Access Compliance Report

Public Rights-of-Way

(Curb Ramps)

Intersection ID: 16513	Main Street: BILTMORE_DR	Cross Street: COLVILLE_RD	Location: NE
ADA ID: DB8A47DA5EE9	Ramp Type: Perp	Initial Pass/Fail: Fail	Overall Compliance: No
Severity Score: 46.25			
Codes/Mitigation Info/Possible Solution		Field Measurements/Component Compliance

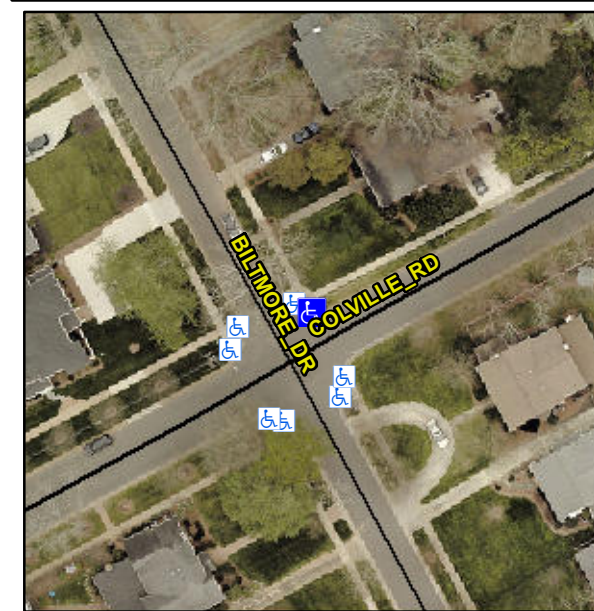
Not Found, R304.5.1, R304.2.2, R304.5.3

Compliance	Description	Data	Compliance	Description	Data
N/A	Ramp Length (in)	78.0	No	Ramp Slope (%)	10.2
No	Ramp Width (in)	41.0	No	Ramp XSlope (%)	7.1
N/A	Flare Type LT	N/A	N/A	Flare Type RT	N/A
N/A	Flare Slope LT (%)	N/A	N/A	Flare Slope RT (%)	N/A
N/A	Flare Traversable LT?	N/A	N/A	Flare Traversable RT?	N/A
N/A	Landing Length (in)	N/A	N/A	DWS Provided?	N/A
N/A	Landing Width (in)	N/A	N/A	DWS Contrast?	N/A
N/A	Landing Slope (%)	N/A	N/A	DWS Length (in)	N/A
N/A	Landing X Slope (%)	N/A	N/A	DWS Full Width?	N/A
N/A	Landing Curb? (Y/N)	N/A	N/A	DWS Offset (in)	N/A
N/A	Shared Landing?	N/A			
N/A	Gutter Ponding?	N/A	N/A	Gutter Slope (%)	N/A
N/A	Gutter Lip Ht (in)	N/A	N/A	Gutter X Slope (%)	N/A
N/A	Painted X Walk1?	No	N/A	Painted X Walk2?	N/A
	X Walk 1 Direction	To SE		X Walk 2 Direction	N/A
N/A	X Walk 1 Width (in)	N/A	N/A	X Walk 2 Width (in)	N/A
	X Walk 1 Slope (%)	3.0		X Walk 2 Slope (%)	N/A
	X Walk 1 X Slope (%)	3.7		X Walk 2 X Slope (%)	N/A

Remove & Replace Entire Ramp.
